22-ZONE-0012 & 22-ZONE-0076

This development
is not compatible.

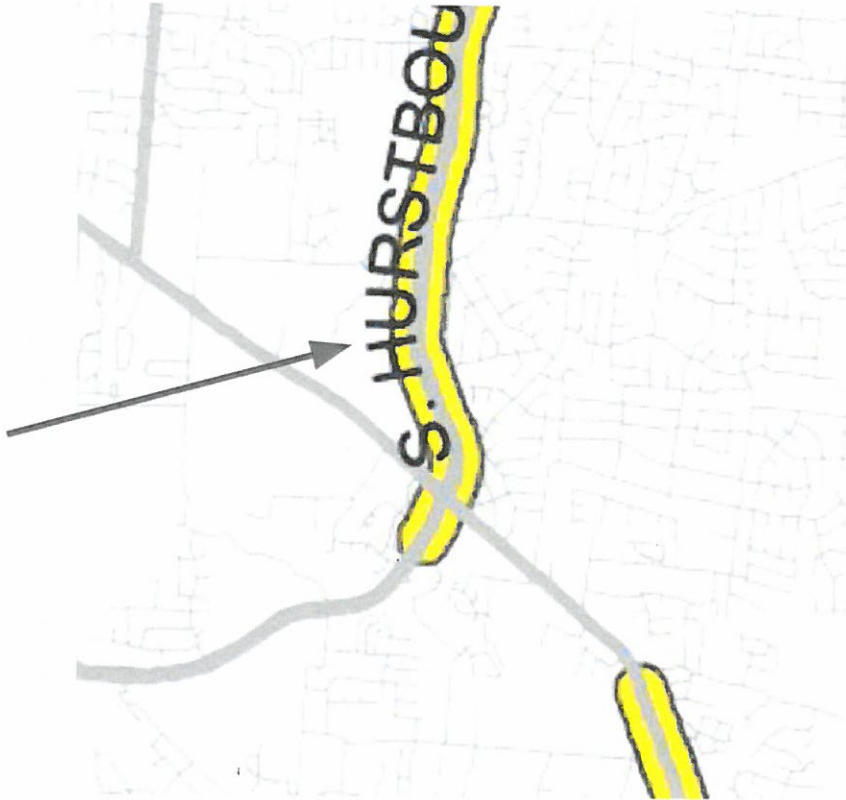
- The proposed uphill development has 3-story buildings with walkouts and balconies towering over rural single-family homes, directly looking at our most private spaces.
- This is the projected view from backyard of 4707 Walnut Hills Dr vs the current view.
- Why can't these buildings be turned perpendicular with a larger setback to preserve privacy and not block natural light?

- This is the projected view from the backyard of 4805 Walnut Hills Dr vs current view.
- These buildings are too tall to be that close to a downhill 0.63 density neighborhood.
- Shorter buildings turned perpendicular with a larger setback would be more appropriate.

- The proposed uphill development is directing car lights and pollution directly toward single family homes.
- The abutting neighborhood is rural with homes on septic tanks, well water, and propane heat.
- This is the projected view from backyard of 4905 Walnut Hills Dr vs current view.
- A continuous berm, fence, and tree combo along the entire perimeter would assist the transition.

Core Graphic 9

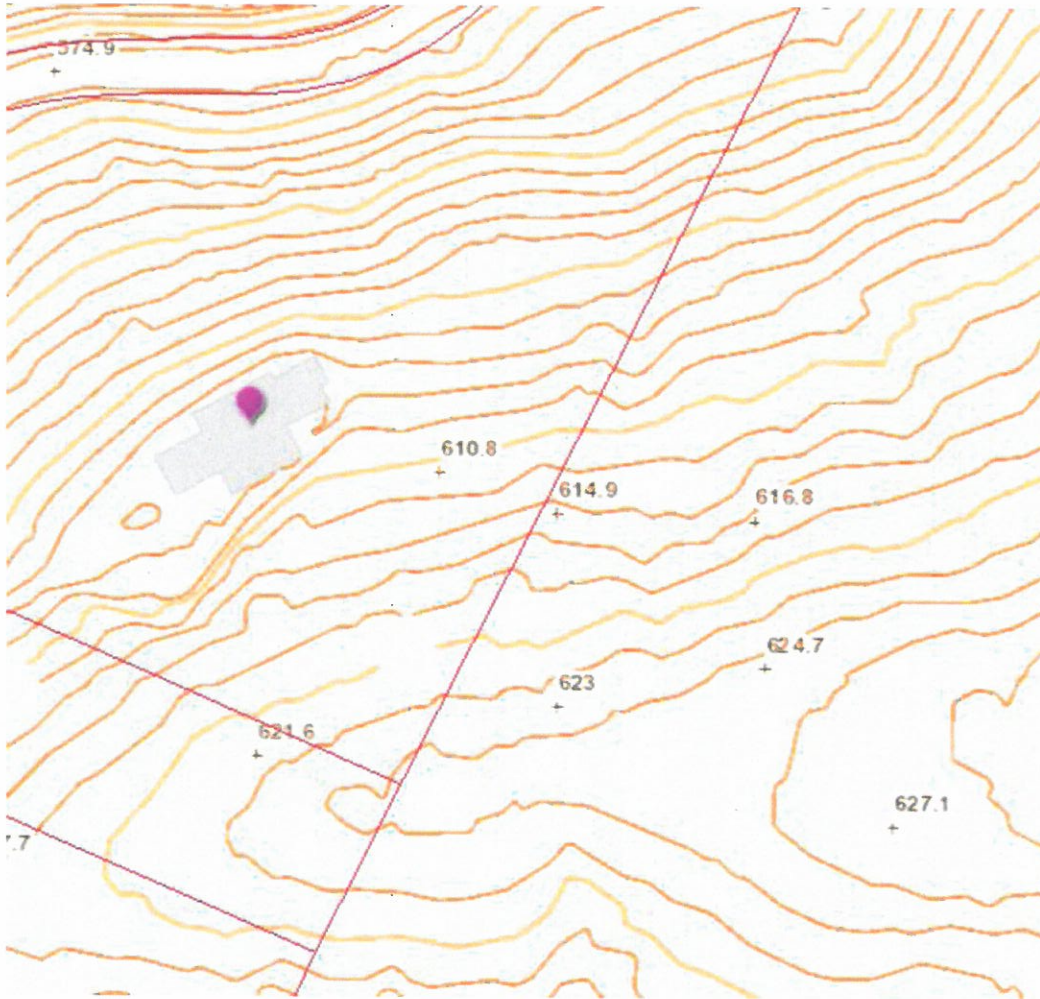
- Adding ~1,200 vehicles, more sitting traffic, and removing all of the trees will make this even worse.
- By adding more tree coverage along the perimeter, we can help improve the air quality and reduce health problems from carbon monoxide exposure.
- This will also assist in the restoration of all of the mature trees that will be destroyed by the developer.

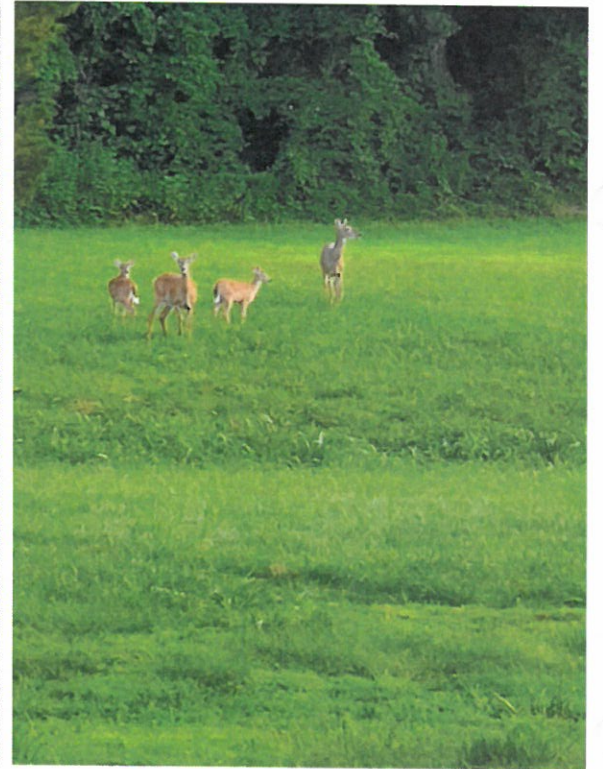
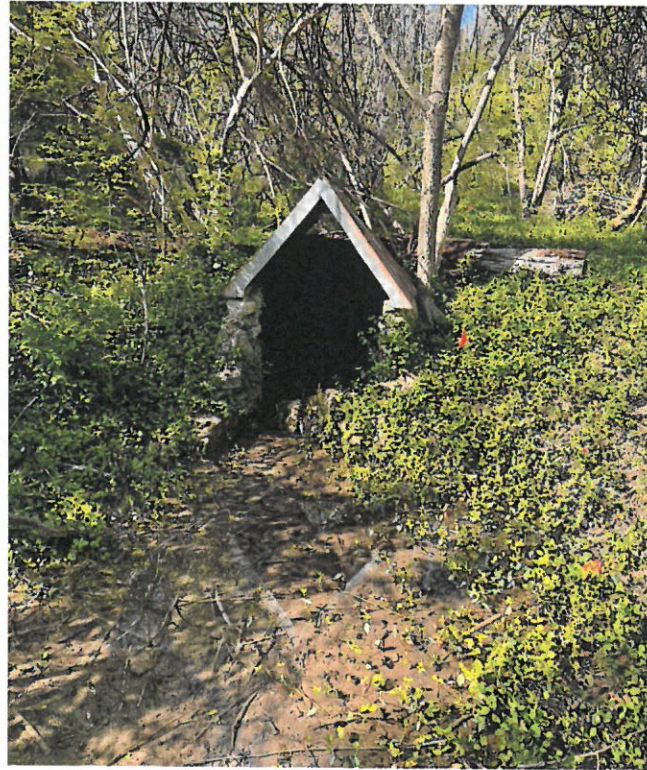
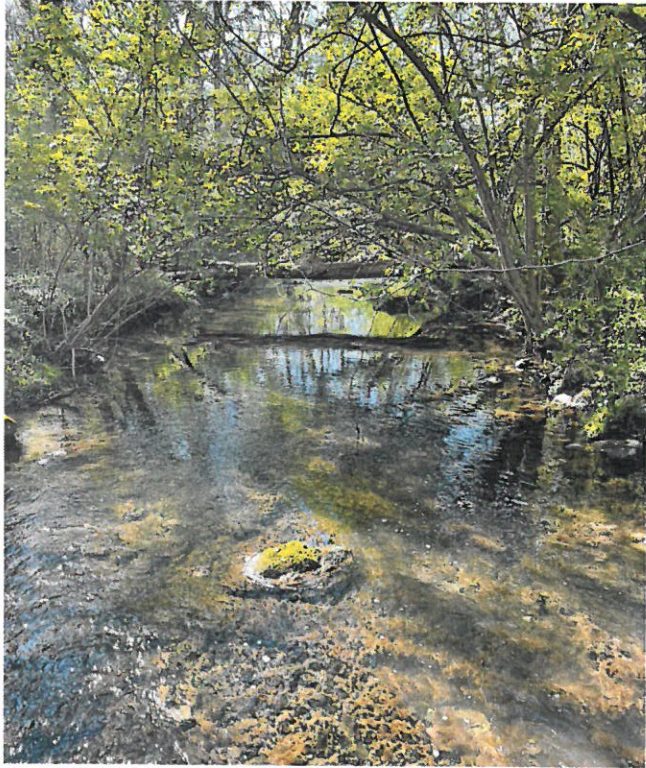
- This basic design is more suited for a military base and not the Scenic Parkway of Hurstbourne Parkway and overlooking Fern Creek.
- This development lacks MIXED USE and aesthetically doesn't fit in with the area.

Smaller 2-story buildings placed in different directions with an abundance of landscaping, trees, large buffer zone, privacy fence, berm, and green space. The building materials use a mix of brick and vinyl.

4700 S Hurstbourne Pkwy underground stream exiting at cliff 4819 Walnut Hills Dr (left), approximate location of sinkholes according to developer's plans, and the approximate location of sinkholes on abutting properties (right).

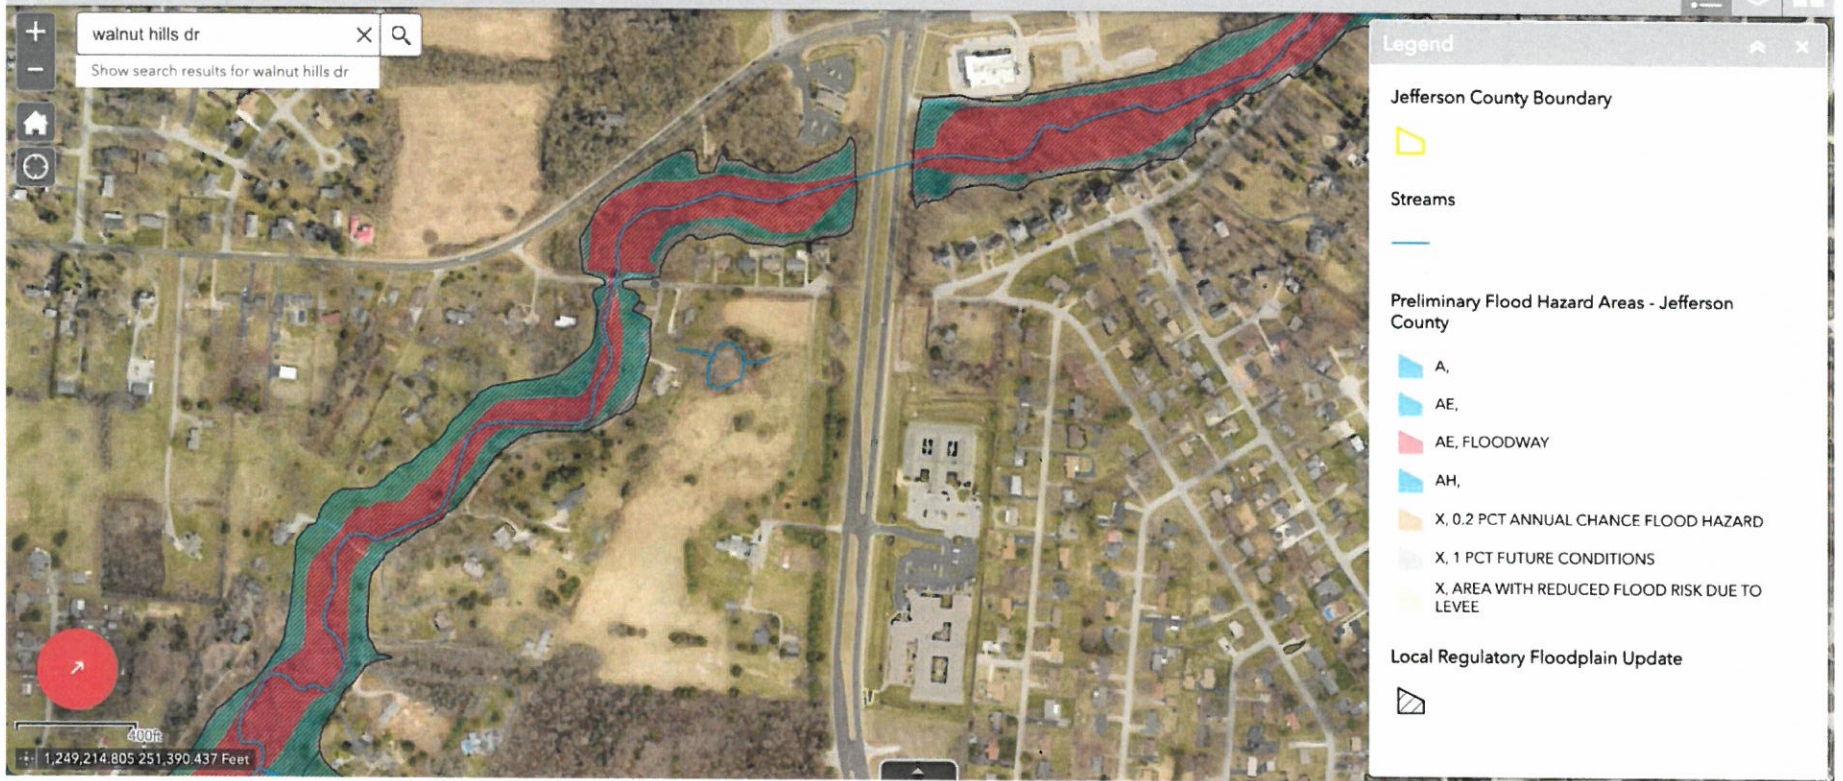
- The proposed development will be built on several sinkholes. This will modify the natural flow of water.
- In reviewing the karst study, section 4.2.1.2 states that: *“Engineering works and site development can result in acceleration of incipient sinkhole development or encourage new sinkhole formation. These features may appear dormant in their existing state, but subsidence can be activated by changes in the natural drainage pattern due to construction works.”*

- This development discourages the natural features of the terrain and requires the destruction of the pond, wetlands, and the waterfall, and adversely impacts the stream at the West corner by relocating the natural drainage beginning at Hurstbourne Pkwy, and adversely impacts the single-family homes located on steep slopes surrounding the development.

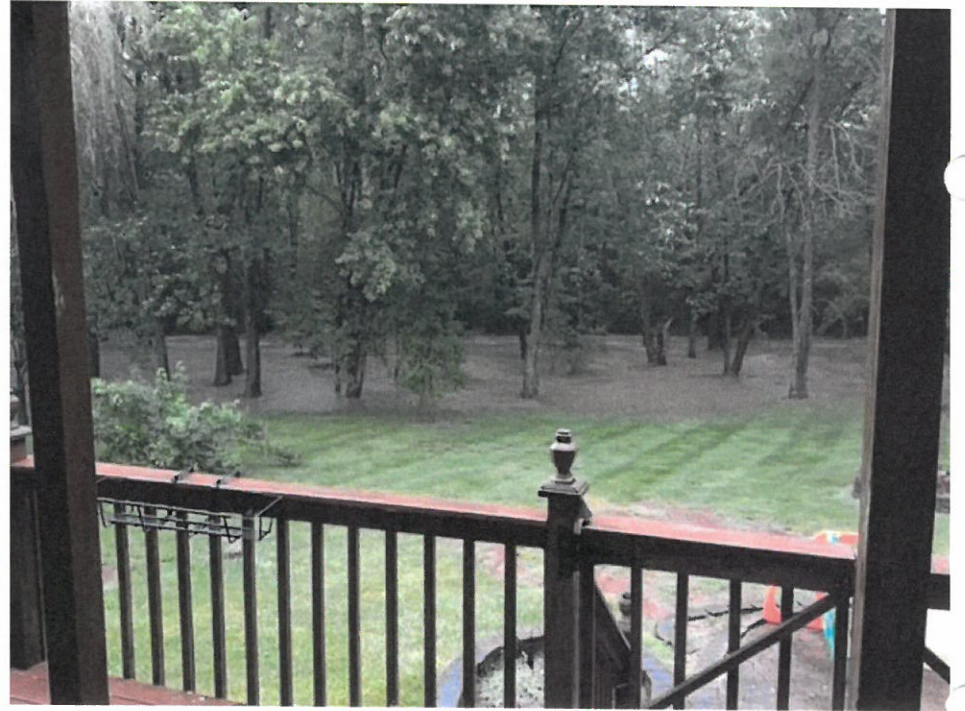
According to Lojic Online, the property is nearly surrounded by steep slopes, unlike any other development on Hurstbourne.
